**From:** Balsam, Briana *MB*  
**Sent:** Monday, April 16, 2012 10:55 AM  
**To:** Logan, Dennis  
**Subject:** Letters to NMFS from various groups  
**Attachments:** Fwd: FW: ESA § 7 Consultation with NRC on Entergy's Pilgrim Nuclear Power Station  
Plymouth Massachusetts; FW: Entergy-NRC Pilgrim Nuclear Relicensing ESA Consultation;  
FW: Entergy-NRC Pilgrim Nuclear Relicensing ESA Consultation; Additional Pilgrim Exhibits

**Docket # 50-293 LR**

**REPLY AFFIDAVIT OF ALEX MANSFIELD**

**Figure 3**

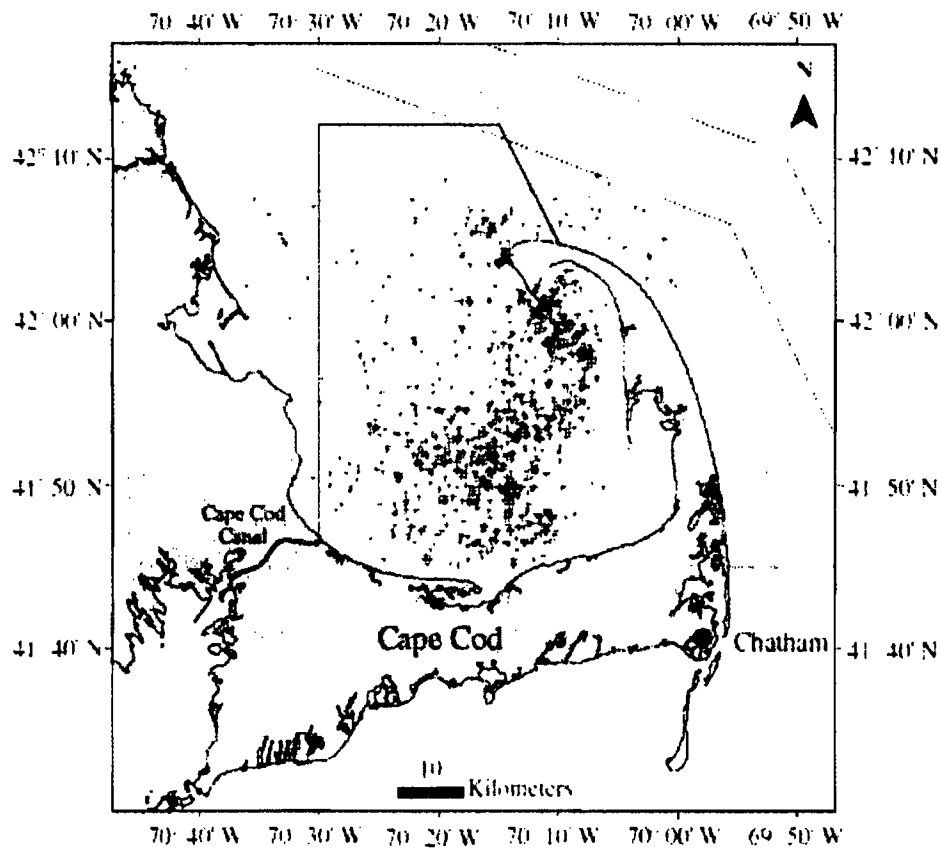
The 2006 BA appears to have based this conclusion of “no effect” on the PNPS EIS, § 2.2.5.37, statement “no whales have been observed in the shallow waters off PNPS....” The Scherer Affidavit ¶50 attempts to refute the sighting data provided in my first Affidavit. Scherer provides information from a recent study that standardized NOAA’s sighting data for North Atlantic right whales, based on Sightings Per Unit Effort (“SPUE”) (Nichols et al. 2008). Two Figures from that report are reproduced here as Figures 3 and 4.

13. Figures 3 and 4 are highly consistent with the figures and information provided in my first Affidavit. The Nichols et al. 2008 report cited in the Scherer Affidavit and Figures 3 and 4 show that whether the data are portrayed as “raw” sightings (Figure 3) or are standardized by SPUE (Figure 4), North Atlantic right whales are found within a 6 mile radius of PNPS and within the “critical area” identified in the “Summary Report: Fish Spotting Overflight in Western Cape Cod Bay in 1993” (Fish Spotting Report) and reproduced in my first Affidavit. My first Affidavit does not dispute the data showing that North Atlantic right whale sighting densities are higher in the eastern portion of Cape Cod Bay as compared the western part; it only disputes the 2006 BA statement that “no [North Atlantic right whales] have been observed in the shallow waters off PNPS....” The data I have provided showing the presence of these whales within the 6 mile “critical area” should be taken into account in determining whether or not the PNPS operations will have “no effect” as the 2006 BA concludes. This data was not taken into account.
